POCONO TOWNSHIP PLANNING COMMISSION

AGENDA

January 13, 2025 6:00 p.m.

**SUBJECT: EXCLUSIVE POCONO PROPERTIES, LLC – 329 SCOTRUN AVENUE
SKETCH PLAN REVIEW NO. 2
POCONO TOWNSHIP, MONROE COUNTY, PENNSYLVANIA
POCONO TOWNSHIP LDP NO. 1422, T&M PROJECT NO. POCO-R0619**

SKETCH SITE PLAN - OPTION 2

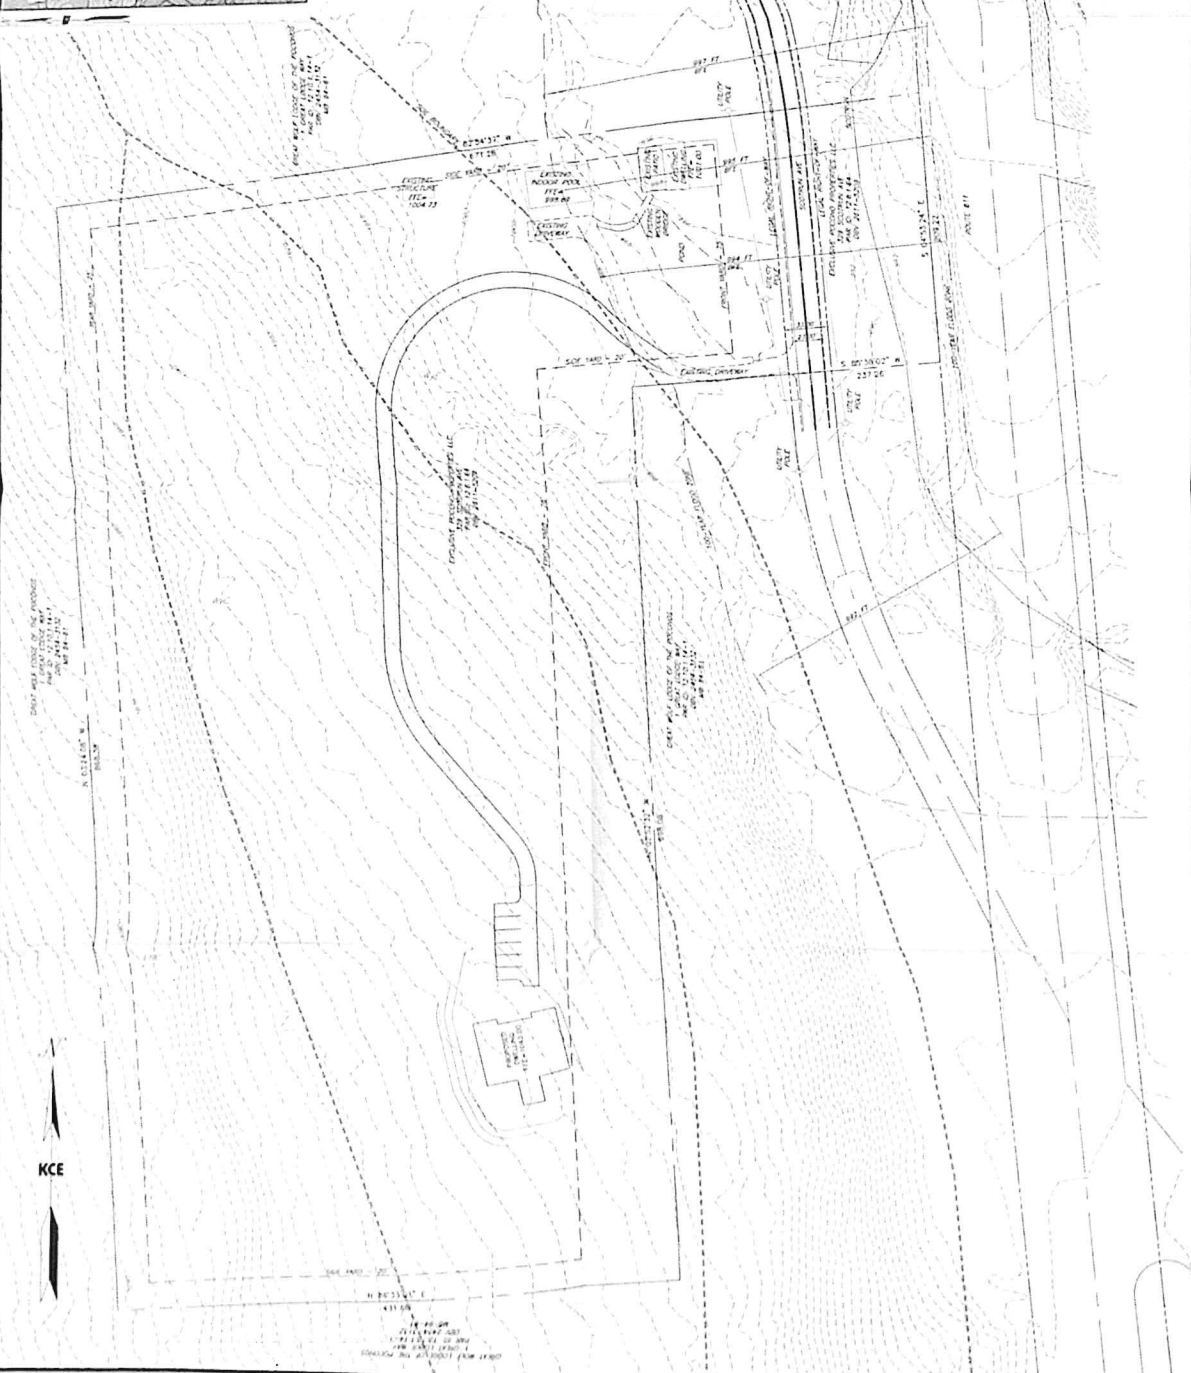
The Applicant shall submit the Sketch Plan to the Zoning Officer for a determination of the proposed use. (From Previous Comment 1) The plan now proposes one (1) transient dwelling unit. The plan shall clearly identify whether the existing single family dwelling will remain as a single family dwelling, or be a part of the proposed “transient hotel complex”. If the single family dwelling will remain, then the proposed use should be revised to “transient dwelling unit” with the single family dwelling to remain.

2. In accordance with Section 470-19.C.(2), the required front yard depth is 75-feet and the side yard width is 20-feet. *The plan shows the 75-foot front yard measured from the Legal Right-of-Way line on the eastern side of Scotrun Avenue. The plan shall be revised to measure the front yard from the Legal Right-of-Way line on the western side of Scotrun Avenue. Also refer to SALDO Comment 10.*

The existing single family dwelling is located within the front yard setback and is an existing non-conformity. The proposed development does not affect the existing non-conformity. (Previous Comment 2) The front yard setback line shall still be revised as required.

- (1) “A vertical aerial photograph enlarged to a scale not less detailed than one inch equals 400 feet, with the site boundaries clearly marked.” *The scale provided on the plan (1"=40") is incorrect when compared to the plan view and shall be revised. (Previous Comment 5.(1)) This shall still be addressed.*

- (2) “Topography, the contour lines of which shall generally be at two-foot intervals although ten-foot intervals are permissible beyond the parcel boundaries, interpolated from USGS published maps. The determination of appropriate contour intervals shall be made by the Planning Commission, which may specify greater or lesser intervals on exceptionally steep or flat sites. Slopes between 15% and 25% and exceeding 25% shall be clearly indicated. Topography for major subdivisions shall be prepared by a professional land surveyor or professional engineer from an actual field survey of the site or from stereoscopic aerial photography and shall be coordinated with official USGS bench marks the location and datum of which shall be shown on the plan.” *The steep slope hatching provided in plan view is not consistent with that in the Legend. The plan view or Legend shall be revised. (Previous Comment 5.(2)) This shall still be addressed.*

- (3) “The location and delineation of ponds, vernal pools, streams, ditches, drains, and natural drainage swales, as well as the one-hundred-year floodplains and wetlands. Additional areas of wetlands on the proposed development parcel shall also be indicated, as evident from testing, visual inspection, or from the presence of wetland vegetation.” *The unnamed tributary to Scot Run shall be shown and labeled on the plan. In addition, the FEMA 100-year floodplain shall be clearly labeled on the plan with reference to the mapping source. (Previous Comment 5.(3)) Scot Run is now shown on the plan. The unnamed tributary to Scot Run (from the existing pond) shall still be shown and labeled on the plan. The top of banks of Scot Run and its unnamed tributary shall also be shown on the plan. In addition, the 100-year floodplain limits shall be revised for consistency with the base flood elevations.*

- (5) “Soil series, types and phases, as mapped by the United States Department of Agriculture, Natural Resources Conservation Service in the published soil survey for the county, and accompanying data published for each soil relating to its suitability for construction (and, in unsewered areas, for septic suitability)”. *Descriptions of the existing soils shall be provided on the plan. (Previous Comment 5.(5)) This shall still be addressed.*

- (7) “A viewshed analysis using GIS or other suitable methodology showing the location and extent of views into the property and along ridgelines from critical points along adjoining public roads and how the views will be affected by the proposed development and what design elements will be used to minimize the visual effects.” *A viewshed analysis shall be provided. (Previous Comment 5.(7)) This shall still be addressed.*

dumps, utilities, fire hydrants, and storm and sanitary sewers.” *Scotrun Avenue and S.R. 0611 shall be labeled on the plan. The existing sanitary sewer, water lines, and any storm sewers shall also be shown on the plan. (Previous Comment 5.(9)) This shall still be addressed.*

10. In accordance with Section 390-48.H.(2), “where a subdivision or land development abuts or contains an existing municipal road of inadequate right-of-way width, the building setback shall be shown on the plans measured from a line which would satisfy the right-of-way requirements for the classification of the abutting road. Additional setback and easement for right-of-way shall be provided in the case of land abutting private roads.” *The required 75-foot front yard shall be measured from the required right-of-way line.*

(Previous Comment 12) This shall still be addressed.
